Access Compliance Report

Public Rights-of-Way

(Curb Ramps)

| Intersection ID: 14618 | Main Street: UNNAMED_ST | Cross Street: WINTERFIELD_PL | Location: S |

| ADA ID: 808DD13F7F9E | Ramp Type: BlendTrans1 | Initial Pass/Fail: Fail | Overall Compliance: No |

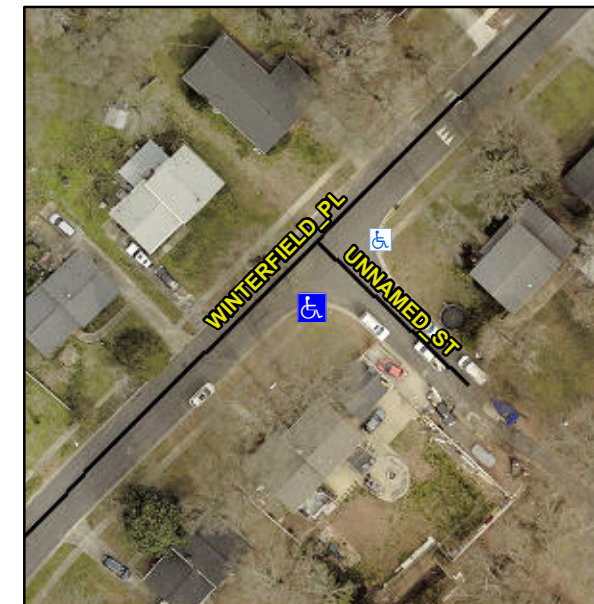
Not Found, R304.5.3

| Compliance | Description | Data | Compliance | Description | Data |
|------------|-----------------------|-------|------------|-----------------------------|-------|
| Yes | Ramp Width (in) | 48.0 | No | BlendTrans XSlope (%) | 6.1 |
| | | | No | Curb Slope (%) | 13.0 |

Remove & Replace Curb Ramp With Two New Directional Ramps or Equivalent.
